Carson Water Subconservancy District Board of Directors Meeting June 21, 2023 Supplemental Materials

<u>Item 17 For Possible Action</u>: Approval of Agreement #2023-15 – HDR Engineering -Pinenut Creek LOMR (FEMA Response), not to exceed \$6,784:

## Summary of Additional Data Required to Support a Letter of Map Revision (LOMR)

Case No.: 22-09-0913P

Figure 2: Surcharges calculation methodology for 2D Evaluation Lines

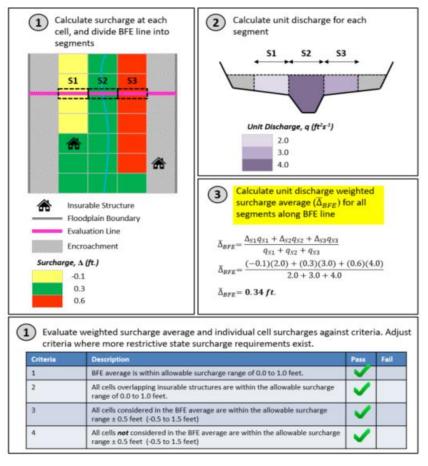
- 6. Please provide the annotated floodway data table for Fish Springs Creek, Cody Wash & Pinenut Creek Tributary and annotated FIS profiles for all of the flooding sources for base flood event and 0.2-percent-annual chance event (where applicable). Please refer to page 22, 23 of the floodway analysis and mapping guidance (December 2020 <a href="https://www.fema.gov/sites/default/files/documents/fema\_floodway-analysis-and-mapping.pdf">https://www.fema.gov/sites/default/files/documents/fema\_floodway-analysis-and-mapping.pdf</a>) and screenshot below for the calculation of floodway surcharges along the evaluation lines.
